**Addendum (1) to JRPP Report – Council response to applicant submission dated 16<sup>th</sup> January 2013**

Height compliance of Lot 49 – proposed amended plans

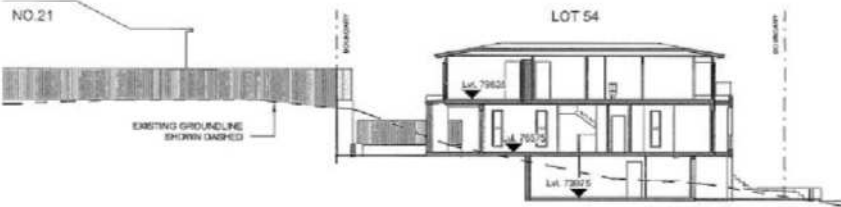
<p><b>Condition 2b</b></p> <p><i>b) The southern upper level building line (exclusive of balcony) of lots 42, 47, 48 and 49 are to be setback 2 metres from the building line (exclusive of balcony) of the level below. The eastern upper level building line of Lot 49 is to be setback 1.5 metres from the building line of the level below.</i></p>	<p><b>Condition 2b</b></p> <p><i>b) The southern upper level building line (exclusive of balcony) of lots 42, 47, 48 and 49 are to be setback 2 metres from the building line (exclusive of balcony) of the level below. The eastern upper level building line of Lot 49 is to be setback 1.5 metres from the building line of the level below.</i></p> <p>1.8 We would request that the panel delete the above condition as it relates to the southern setback of the upper levels to dwellings 42, 47 &amp; 48 (Lot 49 will be addressed separately below).</p> <p>1.9 The design of the southern facades to these houses includes the main façade setback a minimum of 3m from the front boundary. The balconies with their framed supporting elements and roofs create the main façade of these dwellings. This is consistent with the façade design established across the site at Kiah development. For these houses the third storey is setback approximately 2m from the main façade alignment, such that it is setback in excess of 5m from the street frontage. The design provides an upper level setback greater than the 1m required by the design guidelines, to achieve a greater stepped effect and a modulated and articulated building form and streetscape.</p>	<p><b>Not agreed.</b></p> <p>As per the assessment report, the dwellings on Lots 42, 47, 48, 49 occupy prominent positions adjoining the park land. The bulk and scale of the dwellings is excessive relative to its relationship to the park and the topography of the site and contrary to the intent of the Masterplan and Design Guidelines. Further, the height of the proposed dwellings is excessive and contrary to the Masterplan and Design Guidelines which are intent on emphasising a 2 storey scale. The dwellings will be 3 storeys which is only permitted, in accordance with Part 4.2.3 of the Design Guidelines, on sites which allow for a semi-basement level. The FFL of the "lower ground level" is at or above the road level and is clearly not a semi basement, in appearance or by definition (see Part 7.2.6 of the Design Guidelines). Further, these dwellings (with the exception of Lot 48) exceed the Willoughby Local Environmental Plan 2012 height control of 9 metres. The requirement to recess the upper level by 2 metres as per proposed condition 2b is to give a 2 storey scale as intended by the Design Guidelines. This is illustrated below. Further, it will ensure closer compliance with the WLEP 2012 height control.</p>

Condition in dispute	Applicants Response	Councils Response
	<p>1.10 These lots are significantly constrained by the existing fibre optic cable that runs along the frontage of the sites. However, these areas are within the maximum height limit.</p> <p>1.11 As shown in the following extract from Drawing C107A Lots 42 &amp; 47 result in a marginal variation to the height control required by Draft Willoughby Local Environmental Plan of 9 metres. The non-compliance is toward the apex of the roof and will have a marginal impact on the bulk and scale of the dwellings.</p>  <p>1.12 It is therefore considered that the proposed form and design of the dwellings on lots 42, 47 &amp; 48 is appropriate and it is requested that this part of the condition be deleted.</p> <p>1.13 In regards to Lot 49, in response to Condition 2b and the concerns raised in the JRPP report regarding the bulk and scale of this dwelling, we would ask that the panel consider an alternate design option for this lot.</p> <p>1.14 The proposed amended design for lot 49 is within the 9m height limit as shown below and responds to the topography with an appropriate stepping in building height down from Lot 48, (the ridge of Lot 49 is approximately 650mm lower than that of Lot 48). The eastern elevation has a two storey scale and therefore the upper level is not required to have any additional setback. The garage door width is 3.8m, which is the maximum permitted for a single garage door. The design of the upper level is consistent with that on Lots 42, 47 and 48, in that it is setback beyond the main façade in excess of the design guideline requirement.</p>	 <p>With respect to the proposed modifications to Lot 49, as per the assessment report, the alternative design requires proposed public open space in front of Lot 49 to be used as a driveway. This is not considered to be an acceptable outcome as it would reduce the amount of public land and reduce the opportunity for greening and screening the development. Further, it would be inconsistent with the Masterplan and be contrary to the intent of the Masterplan and Design Guidelines which seeks to reduce the dominance of the garaging as viewed from the Public Reserve.</p> <p>The “shared way” referred to in Point 1.16, in accordance with condition 4.15 of DA-2004/521, is a pathway for bikes and pedestrians connecting road No. 3 and Road No. 5. This is a public pathway which will need a width of approximately 2.5 metres. Any potential driveway to Lot 49 (as proposed in the amended plan) would need to be separated from the shared way and need to be a minimum of 3 metres leaving an expanse of 5.5 metres of paved area in front of Lot 49 with limited ability for soft landscaping.</p>

- 1.16 The re-alignment of the dwelling off Road No. 3 results in a significant reduction in building height and bulk of the eastern elevation. Concern is raised in the JRPP report with the loss of landscaped area by providing vehicular access from road No. 3. This area was previously approved as a shared way and therefore is considered appropriate.

- 1.17 Accompanies this letter are amended plans as they relate to Lot 49 for the panels consideration. Refer to Drawings SK01\_170113, SK02\_170113, SK03\_170113, SK04\_170113, SK05\_170113, SK06\_170113, SK07\_170113 dated 17/1/13 prepared by Giles Tribe Architects.

- 1.18 It is therefore requested that Condition 2b be amended to read:
  - b) *The southern upper level building line (exclusive of balcony) of lots 42, 47, 48 and 49 are to be setback 2 metres from the building line (exclusive of balcony) of the level below. The eastern upper level building line of Lot 49 is to be setback 1.5 metres from the building line of the level below.*

**Amended plans shall be submitted to the PCA prior to the issue of the Construction Certificate that incorporate the amended design for Lot 49 as shown on Drawings SK01\_170113, SK02\_170113, SK03\_170113, SK04\_170113, SK05\_170113, SK06\_170113, SK07\_170113 dated 17/1/13 prepared by Giles Tribe Architects.**
